## V2500-A1/A5 SERIES PROPULSION SYSTEMS SERVICE BULLETIN

This document transmits the Revision 3 to Service Bulletin V2500-NAC-71-0280

# V2500-NAC-71-0280

NACELLE – POWER PLANT – BEARING ASSEMBLY, FORWARD ENGINE MOUNT – REPLACEMENT OF SNOOT  
BEARING BALL

Forward Engine Mount Assembly Re-work  
Figure 1 (sheet 1)

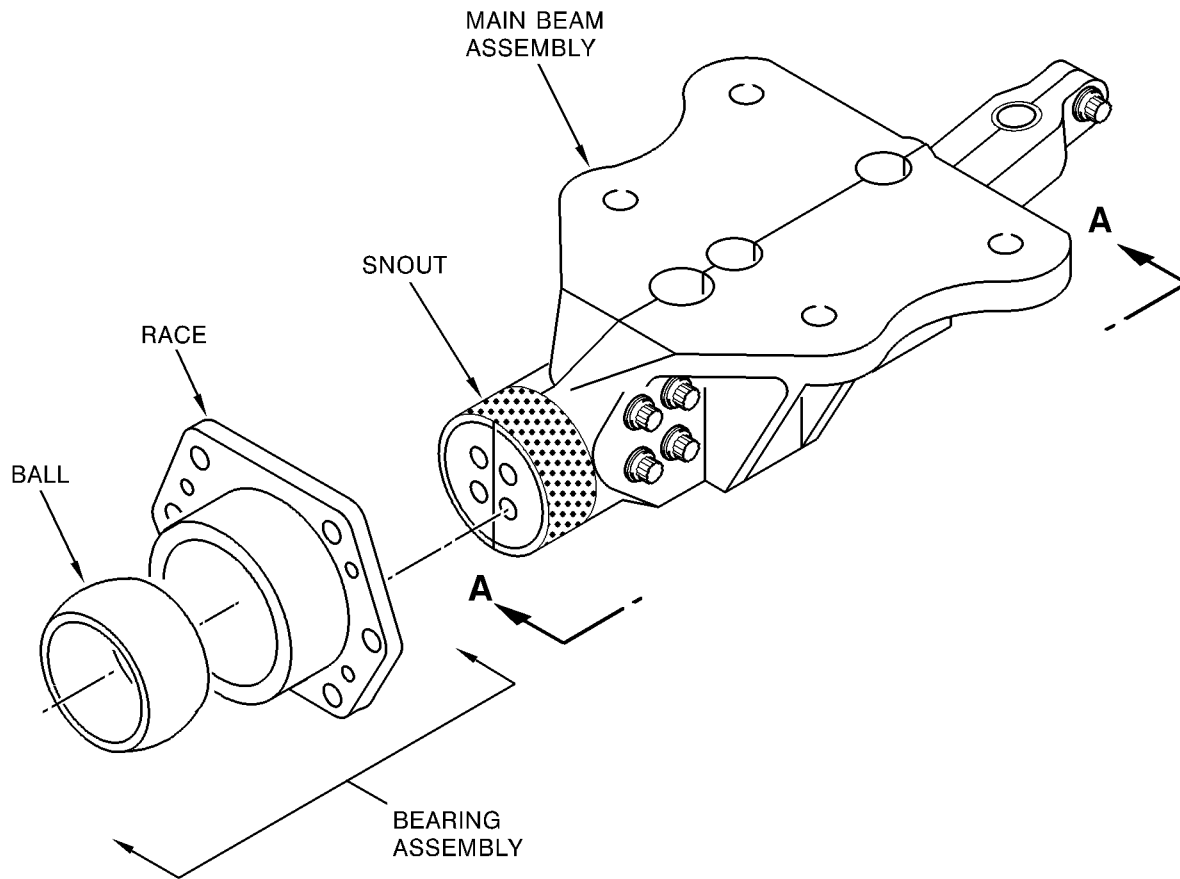
- (7) Measure the minimum diameter of the main beam assembly snout. Refer to Figure 1.
- (a) If the minimum snout diameter, dimension "X", is 2.119-2.1245 inch (53,82-53,96 mm) do Parts 3, 4, and 5 of this Service Bulletin.

- (3) Machine the main beam assembly snout to a diameter, dimension "X", of 2.0985–2.0995 inch (53,30–53,33 mm). Refer to Figure 1.
- (4) Blend mismatch of machine cuts to a 10:1 ratio without making the cuts deeper. – Finish the surface to 32/RMS.
- (5) Measure the minimum diameter of the main beam assembly snout. The diameter, dimension "X", must be 2.0985–2.0995 inch (53,30–53,33 mm). If the minimum diameter is less than 2.0985 inch (53,30 mm), you must replace the main beam assembly with a new 740–2011–505 main beam assembly.

- (b) If the minimum snout diameter, dimension "X", is less than 2.119 inch (53,82 mm) but greater than 2.0985 inch (53,30 mm), do Parts 2, 3, 4, and 5 of this Service Bulletin.

- (c) If the minimum snout diameter, dimension "X", is not greater than 2.0985 inch (53,30 mm), you must replace the main beam assembly with a new 740-2011-505 main beam assembly and then do Parts 3, 4, and 5 of this Service Bulletin.

Forward Engine Mount Assembly Re-work  
Figure 1 (sheet 2)

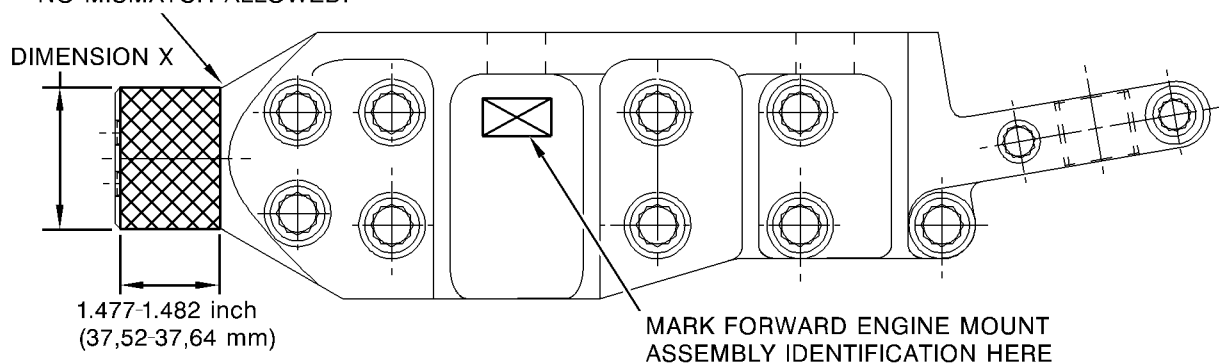
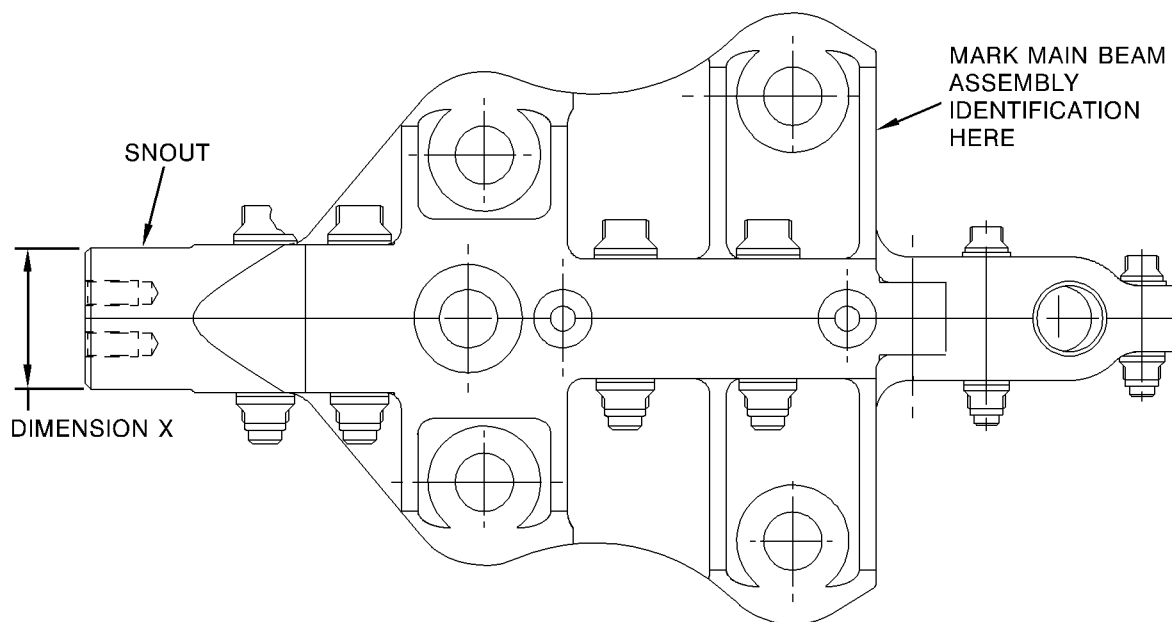
FOR MACHINING OF SNOUT:

0.12 inch (3,05 mm) RADIUS

BLEND TO A SMOOTH

TRANSITION.

NO MISMATCH ALLOWED.
